UNITED STATES PATENT AND TRADEMARK OFFICE

APPLICATION NO.	FILING DATE	FIRST NAMED INVENTOR	ATTORNEY DOCKET NO.	CONFIRMATION NO.
10/756,877	01/13/2004	Lon Richard Buske	10331.1/40176.64USC1	3429

Office Action Summary

Addendum B

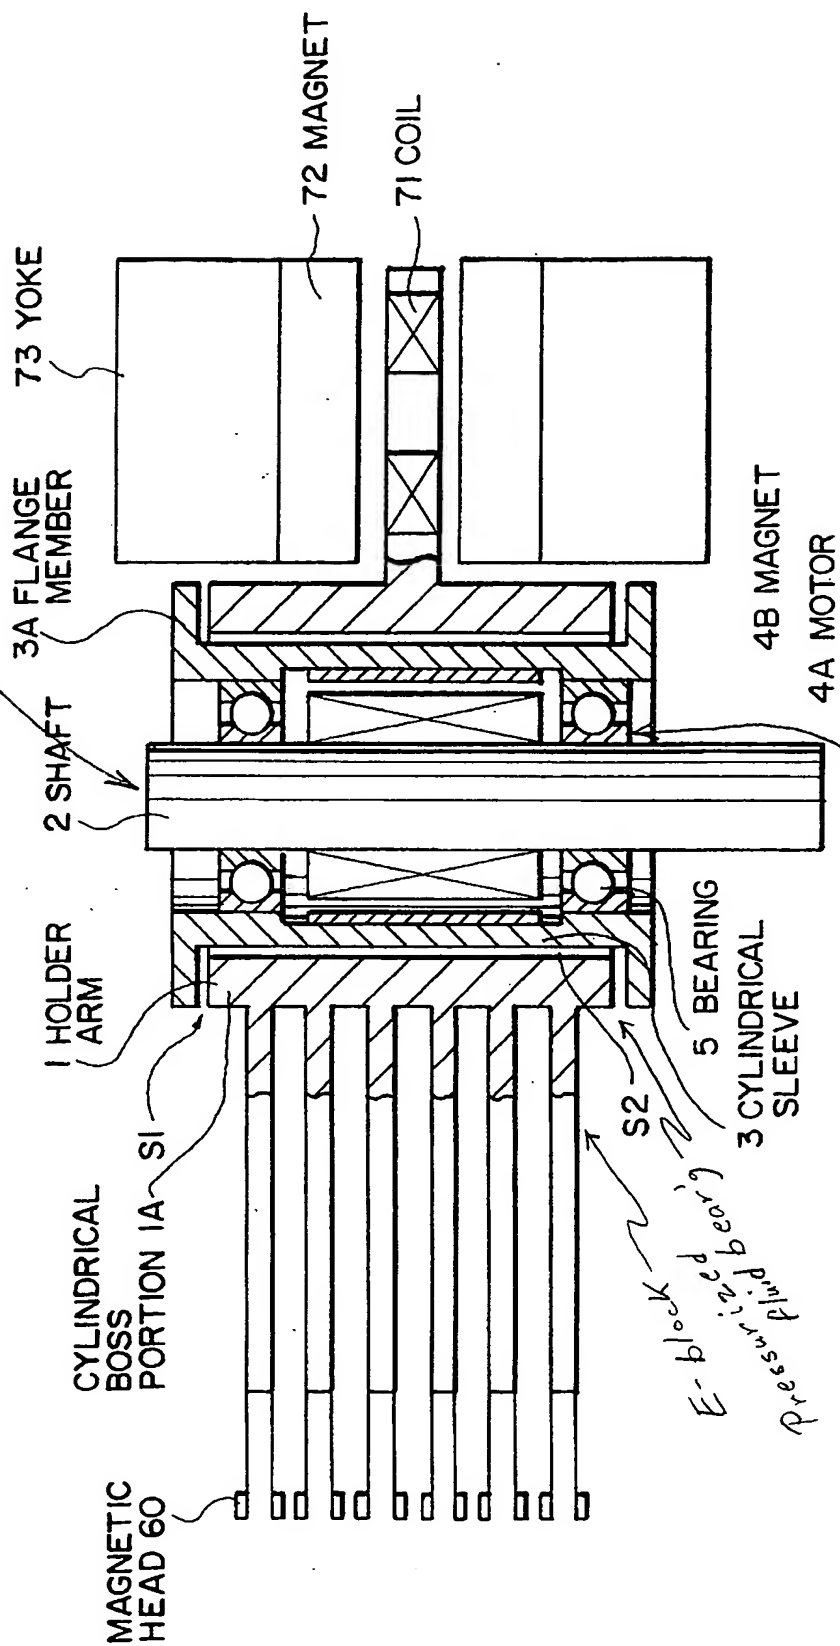
4. Claims 22-25 are rejected under 35 U.S.C. §102(b) as being anticipated by Sanada.

See Fig. 2. Note, to the extent claimed and understood, the structure as shown in Addendum B reads on and performs to the same degree as claimed; e.g. note that Sanada in col.2, line 54, documents that his fluid bearing system is pressurized.
